# UNITED STATES PATENT AND TRADEMARK OFFICE

APPLICATION NO.	FILING DATE	FIRST NAMED INVENTOR	ATTORNEY DOCKET NO.	CONFIRMATION NO.
10/735,923	12/16/2003	Chimanlal N. Gandhi	102 SC-01-US	4267
7590 10/18/2005			EXAMINER	
CHIMANLAL N. GANDHI			DZIERZYNSKI, EVAN P	
c/o UNIT 33-2280 MUNN'S AVENUE			ART UNIT	
OAKVILLE, ON L6H 3L1			PAPER NUMBER	
CANADA			2875	
DATE MAILED: 10/18/2005

**Office Action Summary**

## **DETAILED ACTION**

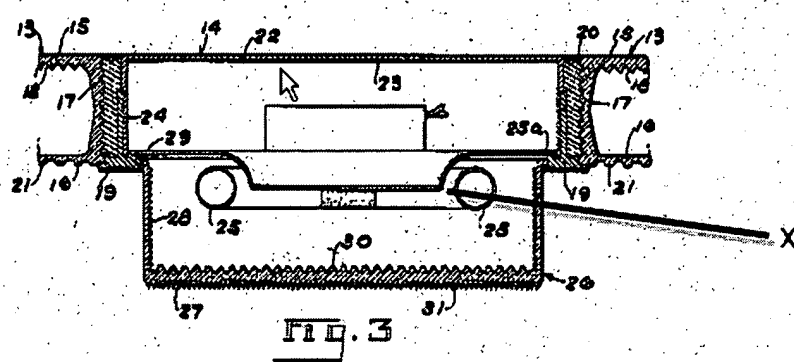
Boyd teaches a lighting fixture 10 for emitting natural and artificial light into a building (fig 3), in which the lighting fixture comprises a main frame body 14. It is inherent that the device has a means for mounting the main frame body onto a building, since the device is a skylight. Boyd also teaches a light transmissive skylight (column 1, lines 62+) mounted in generally overlying relation on the main frame body, and a natural-light passing opening 13 in the main frame body for permitting natural light received from the light transmissive skylight to pass through the main frame body and

into the building. Boyd also teaches a first light socket (not labeled, indicated below as X) operatively mounted on the main frame body for receiving an artificial light source 25 therein, and a reflector means (column 2, lines 20+) operatively mounted on the main frame body adjacent to the first light socket in overlying relation thereto, for reflecting artificial light from the artificial light source outwardly from the lighting fixture and into the building.

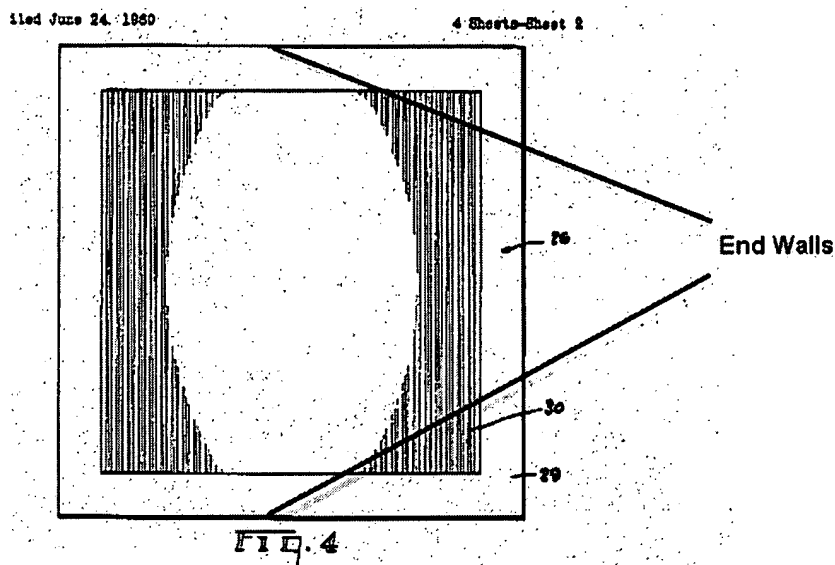
As for claim 3, Boyd teaches the lighting fixture as discussed above, wherein the first light socket is mounted on the reflector means (fig 3).

As for claim 4, Boyd teaches the lighting fixture as discussed above, wherein the main frame body has a roof portion 23 and a wall portion 24 depending from the roof portion.
